816/817 Series 晶片變更說明

EL816/817 Series IR&PT PCN

ECR000084776

Date:2022/10/6

Figure 1. Forward Current vs Forward Voltage

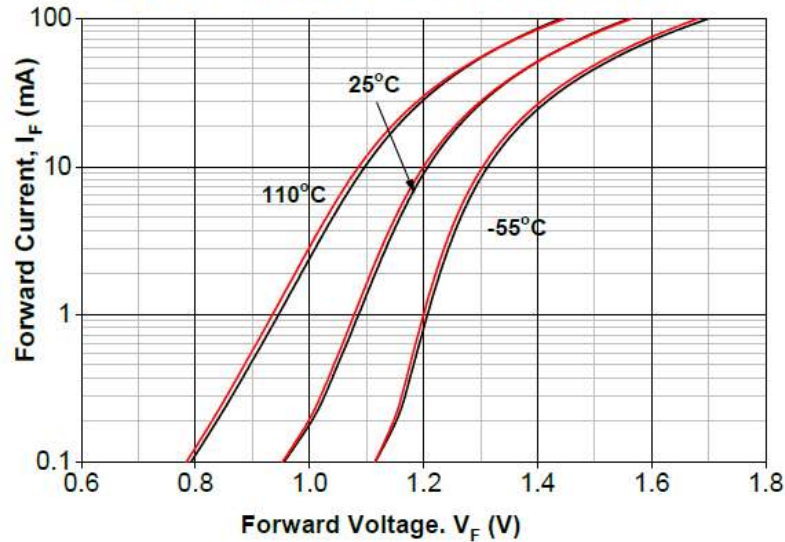
- 為確保按計畫出貨，億光將導入新款晶片.
 - Make sure enhance the lead time, Everlight will implement lead into new 2nd source of IR/PT.
-
- ✓ 目的(Propose)
 - ✓ 電性測試(Electrical Test)
 - ✓ 結論 (Conclusion)

- 電性差異並不大，可以符合原來規格
- Electrical parameter is similar as original dice combo.
- 電性曲線差異也並不大，與原規格差異並不大
- Electrical Curve is almost the same as original one.
